M 1059/81

1059. Bendix. Käynnistinvibraattorin korjaus

**SUBJECT :** Repair of certain starting vibrators utilizing "5" contact bushing (connector).

**SERVICE BULLETIN NO. 614**  
Engineering Aspects  
are FAA Approved

Figure 1 Defect

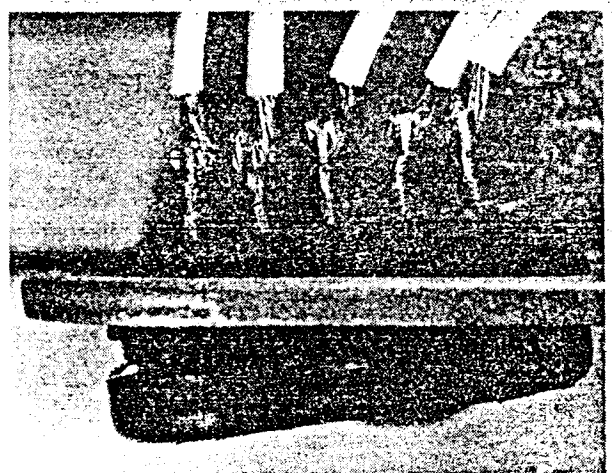
Bushing (connector), P/N 10-382943, may become loose in the vibrator plate and cause the grounding of both magnetos with possible loss of ignition. See figure 1 (defect).

1. Remove starting vibrator from the airframe.
2. Remove cover to expose the internal surface of the terminal bushing (connector).
3. The surface around the terminal bushing must be clean, dry, free of oil, dirt and grease.
4. Reseat the terminal bushing in the mounting plate to its full extent.

5. Use RTV (Silicone rubber sealant, or equivalent, Dow Corning Corp., Midland, Mich. 48640) to seal terminal bushing to the mounting plate. Apply a small bead completely around the bottom of bushing to secure the bushing to the plate as shown in figure 2 (repaired). If RTV is not available, use either Hysol, Epoxi-Patch Kit (general purpose), Hysol Corp., Olean, NY or Conap, Easyoxy Kit (K20 general purpose) 1405 Buffalo St., Olean, NY, or equivalent.
